SANTA YNEZ RIVER VALLEY GROUNDWATER BASIN

MEMORANDUM

SUBJECT: Management Area Boundary Modifications

**PROPOSED BOUNDARY ADJUSTMENTS
 CENTRAL AND EASTERN MANAGEMENT AREAS**

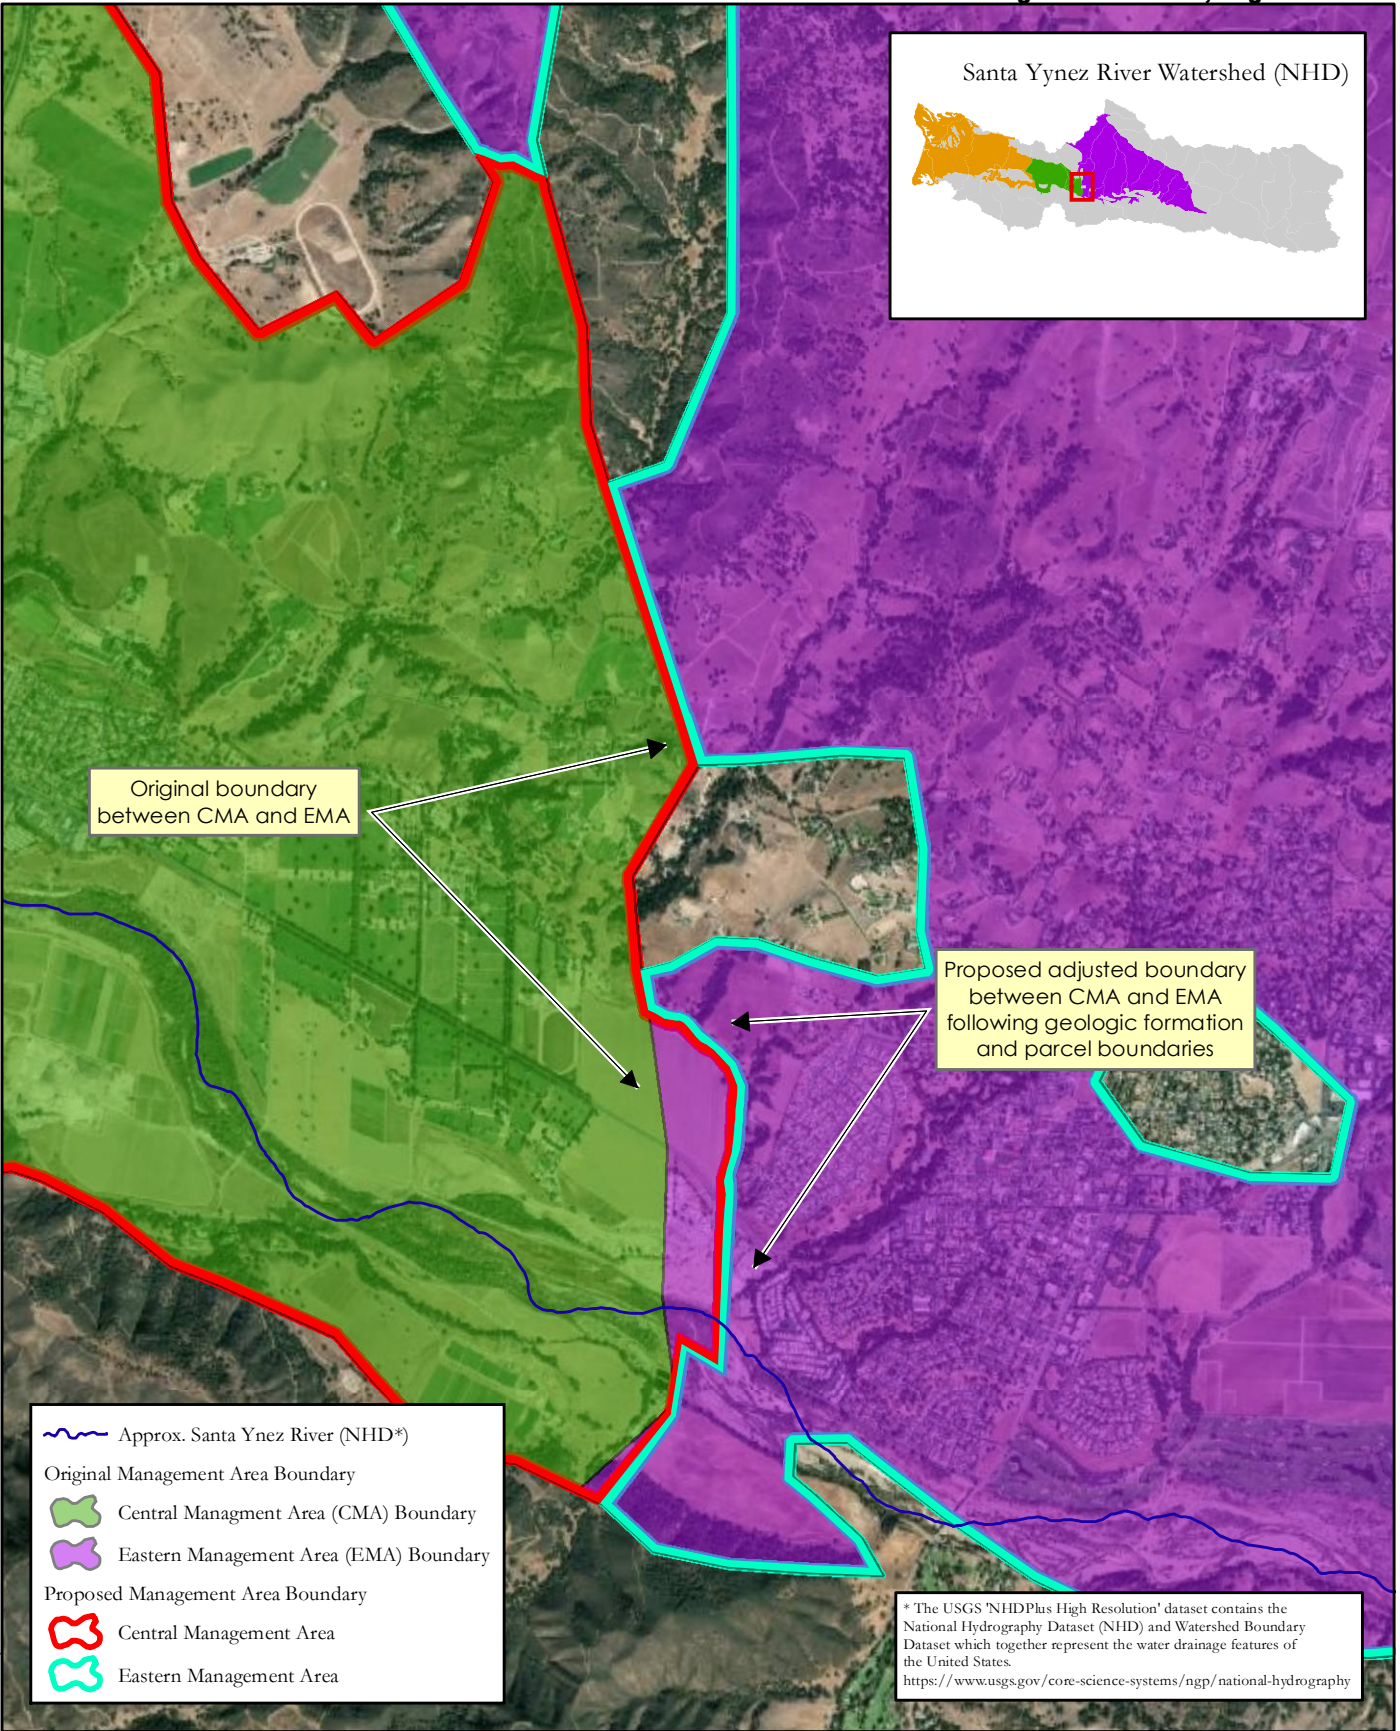
The proposed change to the CMA-EMA boundary adjusts the existing boundary between the CMA and EMA to align with parcel and hydrogeologic boundaries. This change is based on updated Santa Barbara County Assessor parcels maps. Additionally, the existing MA boundary split several parcels. The revised boundary does not split any parcels and follows a topographic and geologic break at the base of Skytt Mesa, on the western side of the City of Solvang. The new boundary coincides with the contact between several geologic units which will simplify water budget calculations. All parcels included in the boundary change were previously part of a GSA. No additional land is subject to the Sustainable Groundwater Management Act (SGMA) as a result of the boundary change, therefore not considered a material change by DWR. Figure 1 shows the original and draft proposed boundary between the CMA-EMA.

Original boundary between CMA and EMA

Proposed adjusted boundary between CMA and EMA following geologic formation and parcel boundaries

Proposed adjusted boundary between CMA and EMA following geologic water-bearing formation boundary and parcels; No exterior DWR Bulletin 118 boundaries are changed.

FIGURE 2

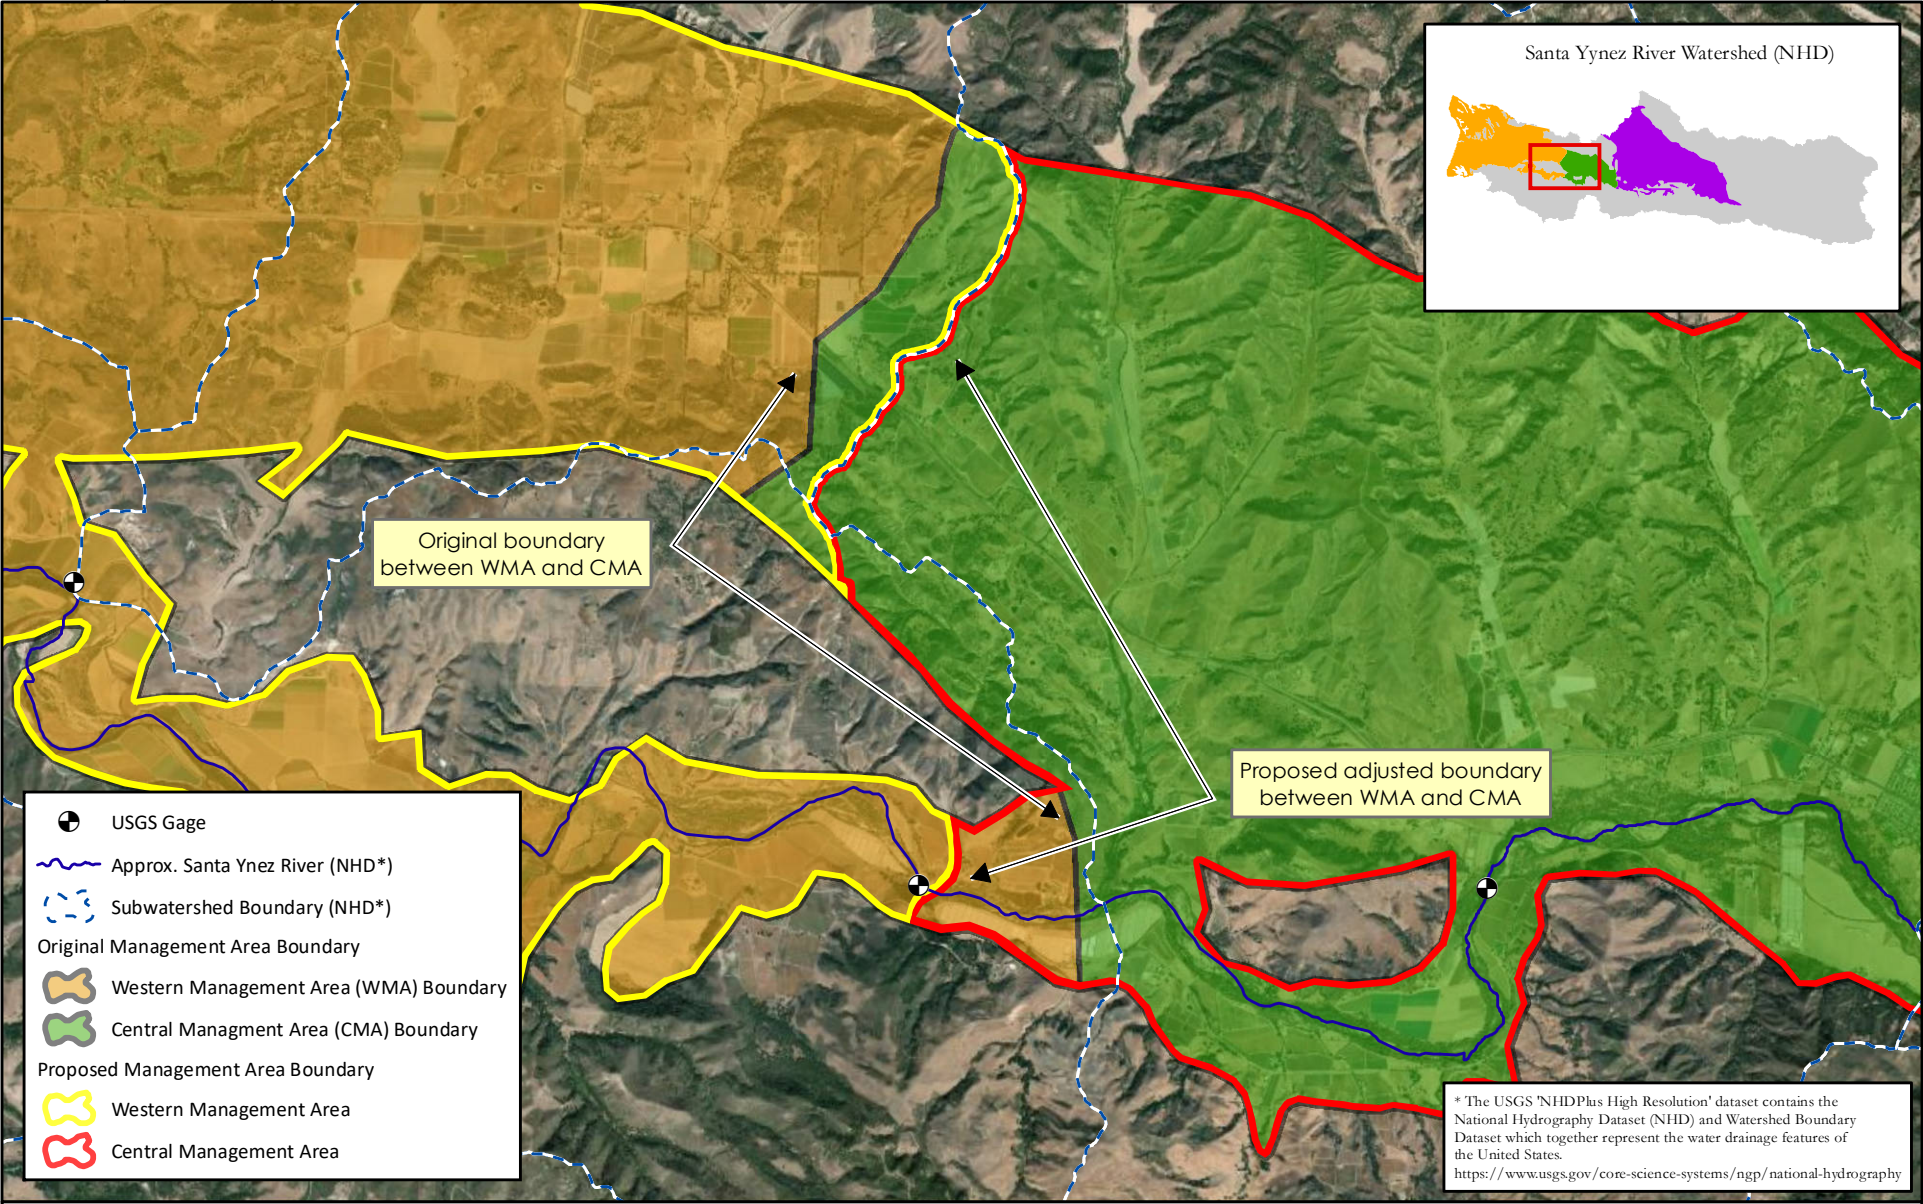
The proposed change to the WMA and CMA boundary is based on the following:

- 1) Aligns the MA boundary with the surface water drainage, the local topography and hydrogeology.
- 2) Encloses a large portion of the Careaga formation within the CMA, which aids in calculations for the water budget.

- 3) Aligns the WMA-CMA GSA boundary to the SYRWCD boundary in the Santa Rita and Buellton Uplands.
- 4) Shortens the boundary between the WMA-CMA, which will simplify water budget calculations.
- 5) Moves the MA boundary at the Santa Ynez River near to a former USGS gauge location (ID 11131000) and a bedrock high. The new boundary is less arbitrary than the previous boundary and will make the calculation of groundwater and surface water flux between the CMA and WMA easier to quantify.

Figure 2 shows the original and draft proposed boundary between the WMA-CMA. All parcels included in the boundary change were previously part of a GSA. No additional land is subject to the Sustainable Groundwater Management Act (SGMA) because of the proposed boundary change, and therefore not considered a material change by DWR.

This map proposes that internal management area boundaries within the Santa Ynez River Groundwater Basin be redrawn to follow watershed boundaries more accurately and to utilize a historical USGS gage location; no exterior DWR Bulletin 118 boundaries are changed.
